**Re: Starbucks Shell  
3501 Menaul Blvd NE  
30-Day Temporary Certificate of Occupancy  
Transportation Development Final Inspection  
Engineer's/Architect's Stamp dated 2-10-20 (H16D083E)  
Certification dated 9-3-20**

**Re: Transportation Final Certificate of Occupancy  
Starbucks Shell  
3501 Menaul Blvd. NE**

NORTH  
A1  
SITE PLAN  
1" = 10'-0"  
0 10' 20'

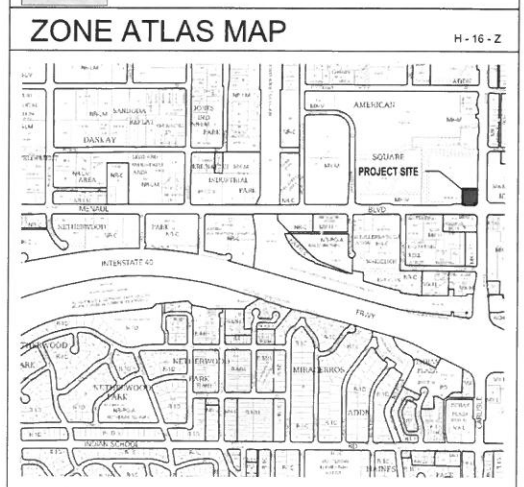
The following items were revised in the field due to incorrect information for the existing city sidewalk fronting Menaul:

1. Concrete walkway that is used for access to the building entry on the south side of the building was extended to the east in order to meet required code for accessibility from the City sidewalk along Menaul, to the southern entry doors.
2. Concrete walkway was rerouted to go around an existing tree that was located along the Menaul frontage.

The following items deviate from the original plan due to the concern that a car backing out of the parking stall will back into a vehicle in the adjacent drive thru lane due to inadequate landscape buffer (area clouded on site plan for clarity):

1. Back up area is approximately 3'-0" deep in lieu of the 5'-0" reflected in the plan.
